112 EDMUND PLACE
BRUSH PARK CDC

APRIL 18, 2019

Re: Brush Park CDC Response Letter – 112 Edmund, 2827 John R. and 105 Alfred Project

112
EDMUND PLACE

PREVIOUS DESIGN

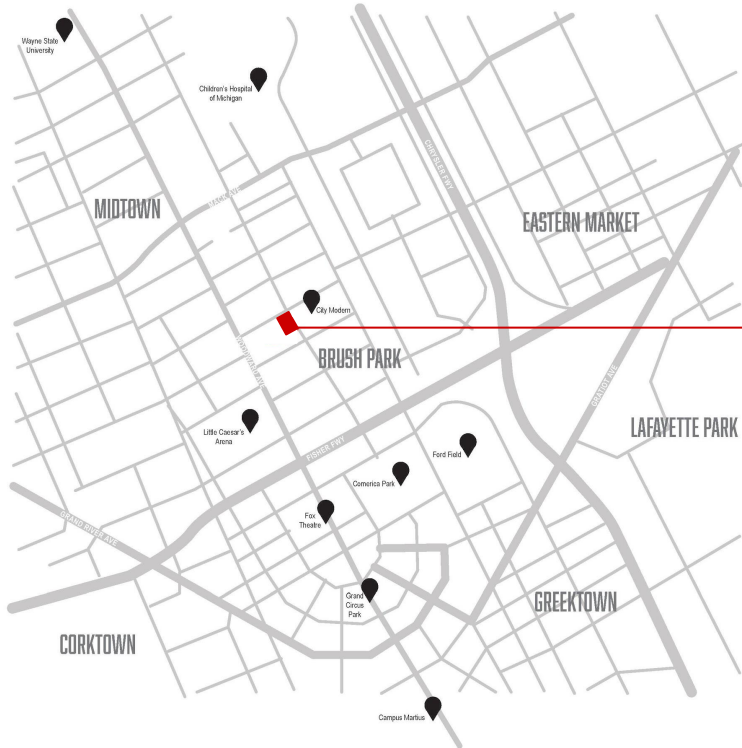
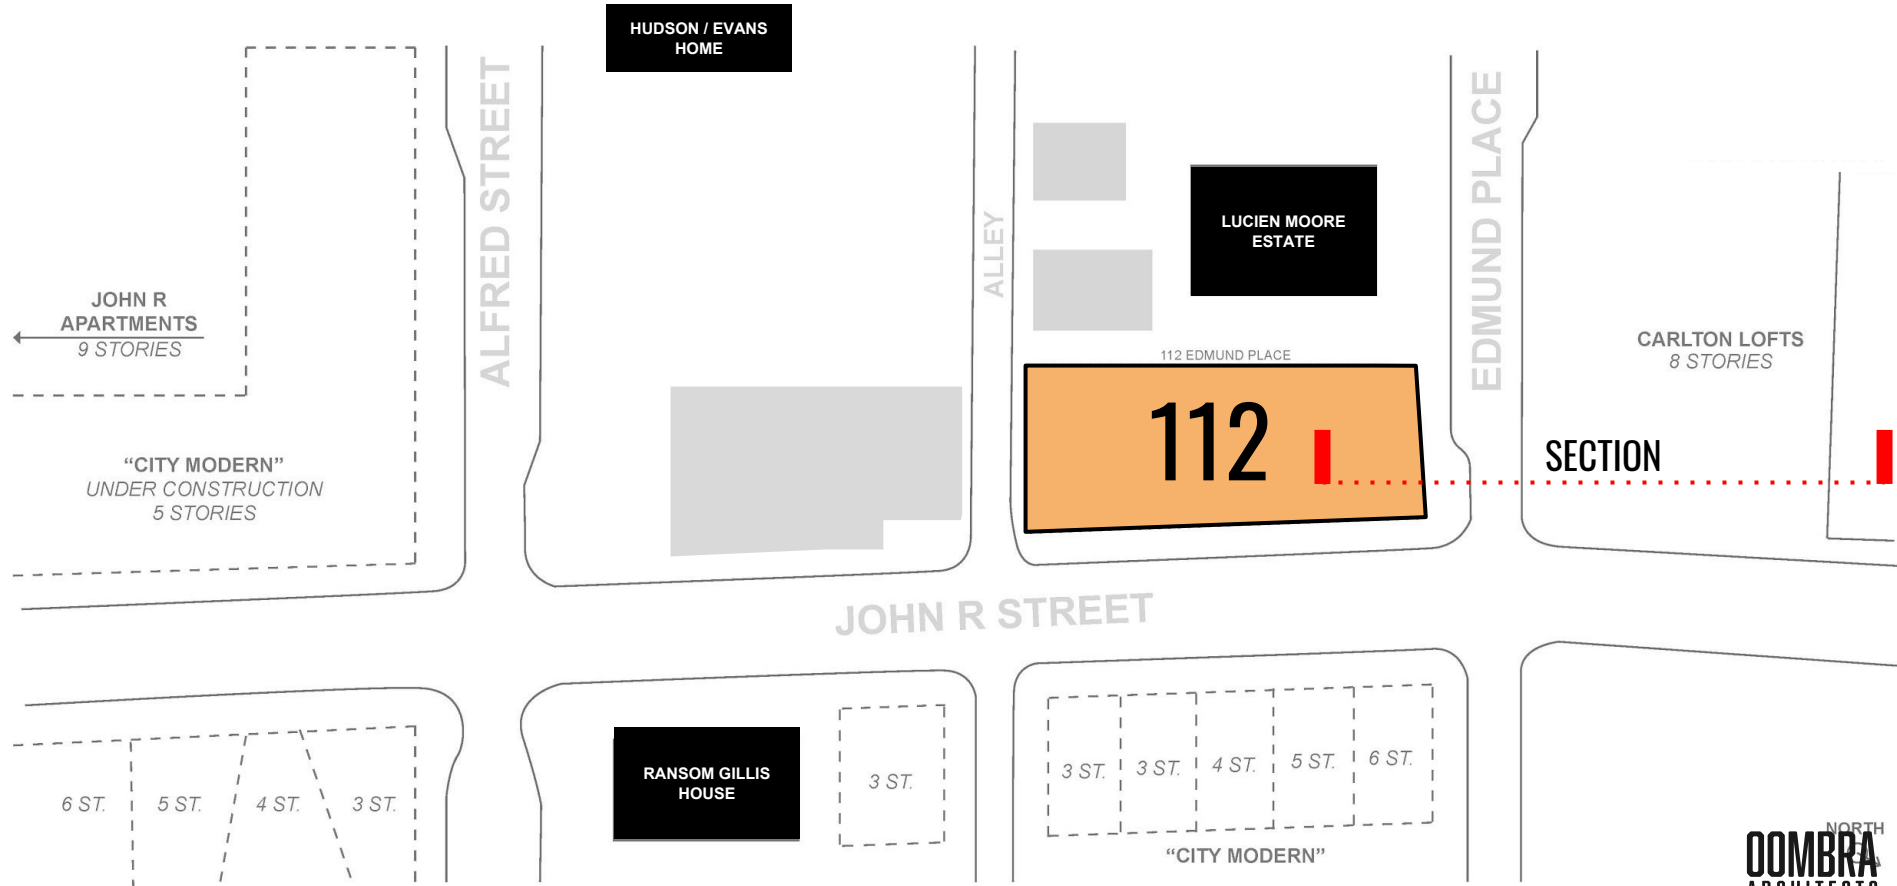
1. **Parking.** Several Board Members believe that the Developer is using conservative and outdated parking standards. The total provided is 140 spaces for 39 units + commercial/retail space. Other neighborhood developments within the Greater Downtown area are using more progressive standards (1 space per unit; often 0 spaces for commercial use), and the DRAFT Form Based Code ("FBC") suggests more reasonable standards (1 space per unit max.; 1 space per 500 SF commercial max.); however, the developer is using the City of Detroit's generic zoning standard (rather than one of the City's more recent standards for transit-oriented neighborhoods) which leads to excessive parking spaces and induces driving as a mode of transportation. While recognizing that both residents and retail visitors still need some parking, a more reasonable amount might be around 94 total spaces provided (39 residential spaces + 55 commercial/retail spaces, using the Draft FBC ratios).

Several Board members feel that the parking deck concern is a derivative or responsible for most other concerns of the community: curb cut concerns, building height concern, and density. By reducing the height of the Edmund Building, utilizing the proposed "Commercial space" as residential to replace the lost floors on Edmund--possibly with highly profitable micro-apartments, many of which would be students that are moving away from vehicles and embracing the walkable neighborhood concept, you would greatly reduce the amount of parking needed for the project, and possibly remove the need for a parking deck. At a minimum, CPC should request a traffic study to demonstrate the potential impact that the parking deck could have on the community and the immediate adjacent neighbors in particular.

2. **Curb cuts on Edmund and Alfred.** Several board members would prefer to adhere to the historic precedence of the neighborhood and avoid curb cuts. We recognize that previous development (e.g. Crosswinds) have incorporated them, however the curb cuts designed for this Project aren't intended for residents to park, but for thousands of retail/commercial patrons to use frequently, diminishing the safety and comfort for pedestrians on the street.

4. **Building Height.** We acknowledge that the CDC previously voted to support the 7 story height of the 112 Edmund building, but add that this vote was taken prior to concerns from owners and residents of the Carlton being brought to the CDC's attention. Several of our board members continue to express concerns regarding the height of 112 Edmund, irrespective of its effect on views at the Carlton. Some are concerned that an additional 7 story building may set a new, undesirable precedent for the neighborhood and whether the height is in the spirit of the

- REDUCED BUILDING HEIGHT FROM SEVEN TO FIVE STORIES (82' TO 68')

- REDUCED OVERALL BUILDING SQUARE FOOTAGE FROM 82KSF TO 50KSF

- REMOVED STREET CURB CUT FROM EDMUND PLACE - ONLY ACCESSED FROM ALLEY

- REDUCED PARKING COUNT FROM 48 SPACE TO 31 SPACES - NO UNDERGROUND PARKING

- REDUCED RETAIL PROGRAM FROM 5KSF TO 1.2KSF (NO PARKING REQ'D FOR RETAIL)
- REMOVED COMMERCIAL OFFICE PROGRAM (REDUCED AMOUNT OF PARKING REQ'D)
- INCREASED UNIT COUNT FROM 32 TO 36

GROUND FLOOR PLAN

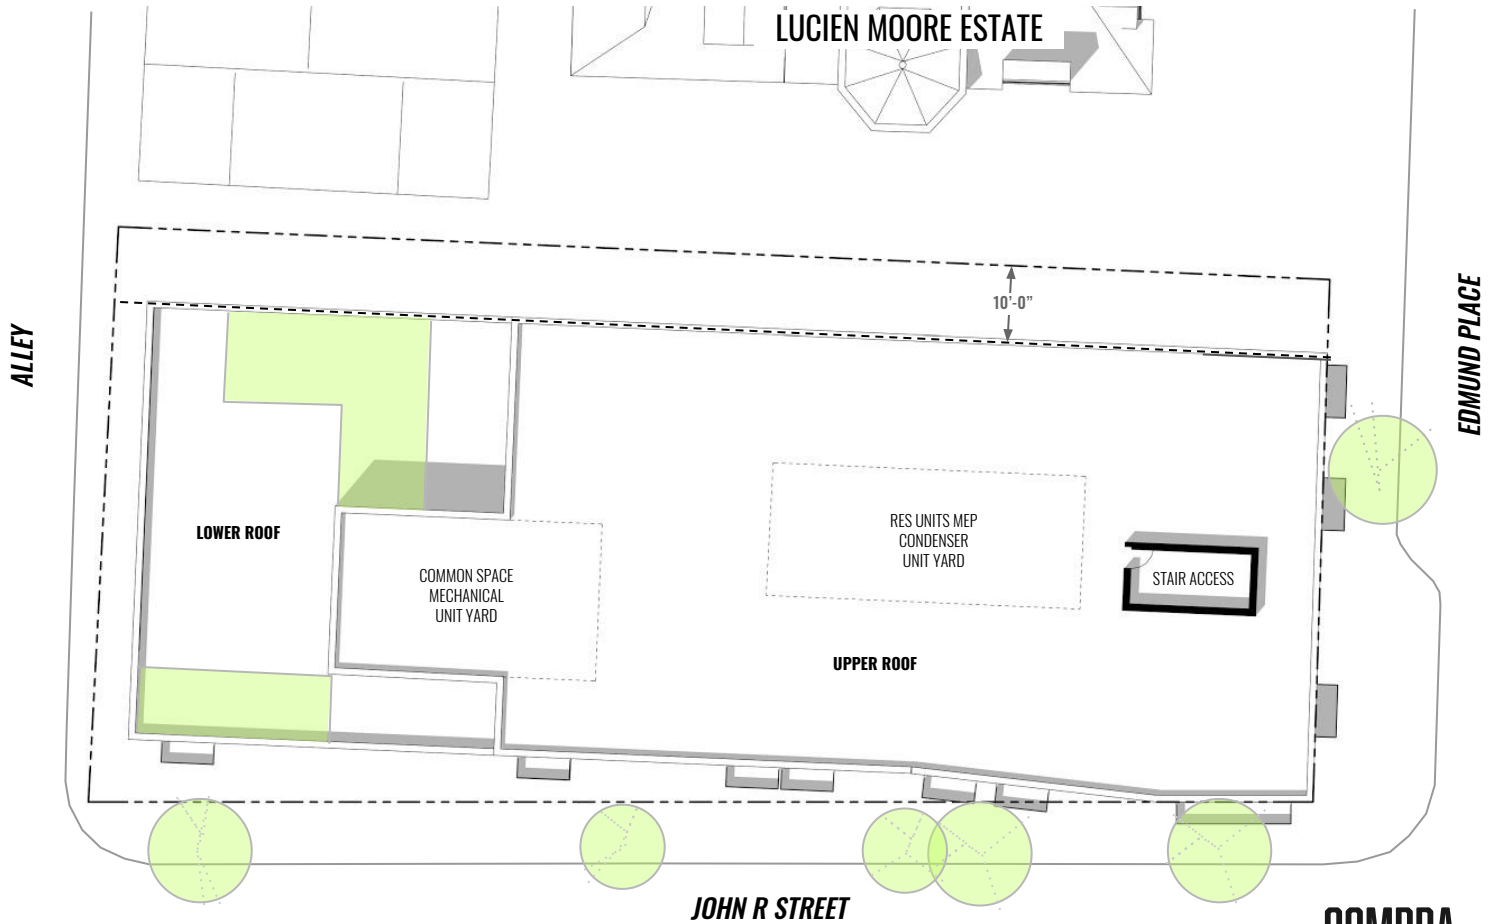
Additionally, some board members are concerned about the use of the alley for parking deck egress. Residents that use that alley as their only means of parking (since they don't have curb cuts) will likely be locked in to their parking spots during high traffic times, and will have to deal with the additional noise and pollution of those 1000s of vehicles standing and idling next to and behind their residences.
